Evans Ground Storage Tank Rehabilitation Project - RFCSP
Solicitation Number: CO-00510
Job No.: 20-0130

ADDENDUM 1
April 25, 2022

2 T-1 TANK AERIAL
NTS

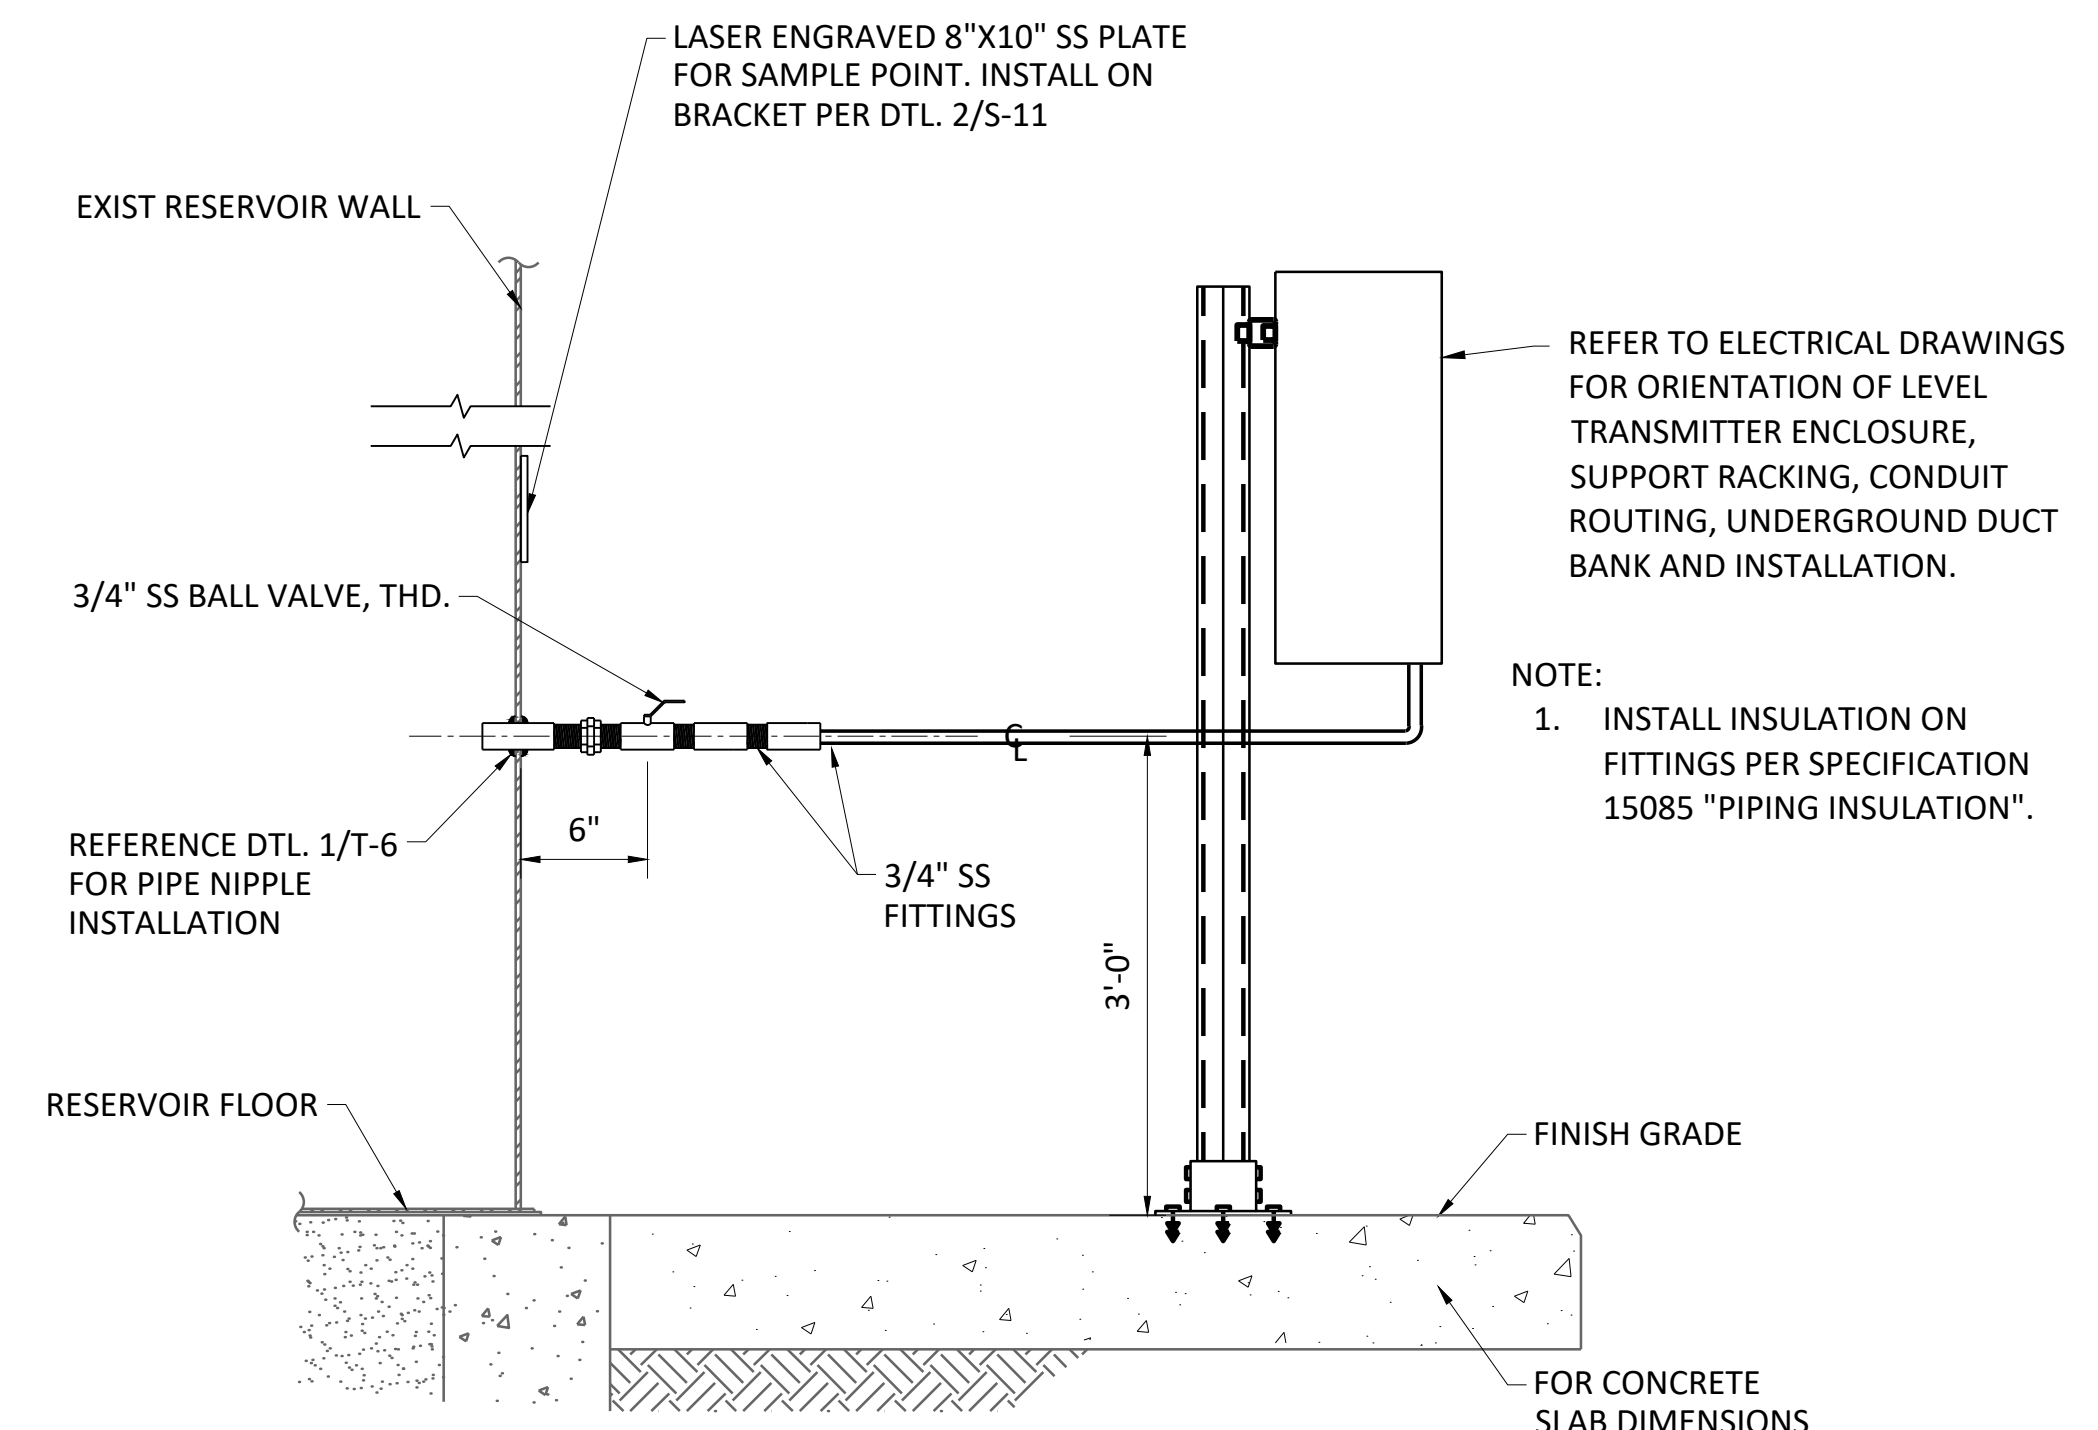
5. **Sheet S-4 and detail 5/T-2 shows the center hatch to be covered with a plate but detail 2/T-1 states to replace with a 36x42 hatch. Please clarify.**

1. **Remove and replace plan sheet T-1 “Tank Exterior Improvements I” in its entirety.**

Response: The center hatch is to be removed and replaced with a cover plate. See item 1 under “Changes to the Plans”.
